PWROG-17031-NP-A Revision 1

Update for Subsequent License Renewal: WCAP-15338-A, “A Review of Cracking Associated with Weld Deposited Cladding in Operating PWR Plants”

SUBJECT: FINAL SAFETY EVALUATION BY THE OFFICE OF NUCLEAR REACTOR REGULATION FOR THE PRESSURIZED WATER REACTOR OWNERS GROUP TOPICAL REPORT PWROG-17031-NP, REVISION 1, "UPDATE FOR SUBSEQUENT LICENSE RENEWAL: WCAP-15338-A, 'A REVIEW OF CRACKING ASSOCIATED WITH WELD DEPOSITED CLADDING IN OPERATING PWR PLANTS'" (EPID L-2018-TOP-0022)

Subject: **Westinghouse Response to U.S. NRC Request for Additional Information for the Review of Generic Topical Report No. PWROG-17031-NP, Rev. 1**

Figure 1. K_{Ic} Curve with 200 ksi√in Upper Shelf

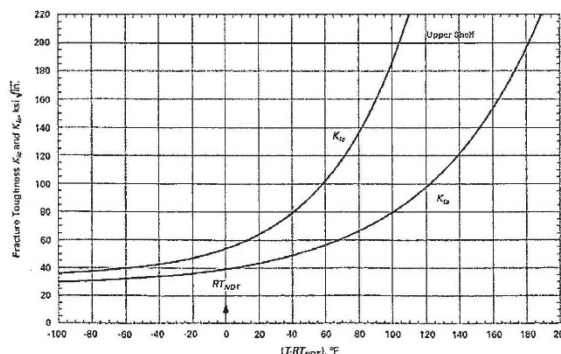
Sections 5.5 and 5.6 of the TR address continued implementation of the same allowable flaw sizes that were previously established for 60-year applications in WCAP-15338-A (October 2002, ML083530289). This is based on consideration of the same governing transient characteristics for 3-Loop plants, as well as the continued use of time-invariant upper shelf fracture toughness (K_{Ic}) of 200 ksi√in for all transient analyses.

Considering the RPV shell axial stress versus RPV shell hoop stress due to RCS pressure and a fixed K_{Ic} value of 200 ksi√in, please explain how the IWB-3610 analysis of the Large Steamline Break transient can result in a more limiting critical flaw depth (2.21 in.) for the continuous circumferential flaw compared to the 2.50 in. critical flaw depth for the continuous axial flaw. If this is a typographical error, please correct it in WCAP-15338-A and in the TR.

PWROG-17031-NP [2] and WCAP-15338-A [1] calculate K_{Ic} , fracture toughness per ASME Section XI, Appendix A, A-4200. It is noted that K_{Ia} was not used in the underclad cracking evaluation. Since there is no prescribed upper limit in the ASME code, 200 ksi√in was conservatively used as a maximum value (or "upper shelf"), even if the calculated K_{Ic} is higher per the ASME Section XI, Appendix A, A-4200 formula. See Figure 1 for a visual demonstration of the 200 ksi√in value superimposed on the ASME Section XI, Appendix A K_{Ic} curve.

For the Steam Generator Tube Rupture and Small LOCA Level C and D transients, the calculated K_{Ic} exceeds 200 ksi $\sqrt{\text{in}}$ when using the 270°F 10CFR50.61 PTS screening criterion for RT_{NDT} . Typical Westinghouse plants have performed Leak Before Break (LBB) analysis and the implementation of LBB eliminates Large LOCA. Individual plants should confirm the implementation of LBB when referencing this report.

It is important to note that the Level A/B allowable flaw size from PWROG-17031-NP [2] is 0.67", while the Level C/D allowable flaw size is 1.25". The 60-year to 80-year reduction of K_{Ic} and the allowable flaw size for Level C/D due to a fluence increase would have to be more than 46% in order for the Level C/D allowable flaw size (1.25") to be smaller than the Level A/B allowable flaw size (0.67"). This reduction is unlikely given the change in fluence and radiation damage from 60 years to 80 years. Therefore, the Level A/B allowable of 0.67" in the PWROG report remains bounding.
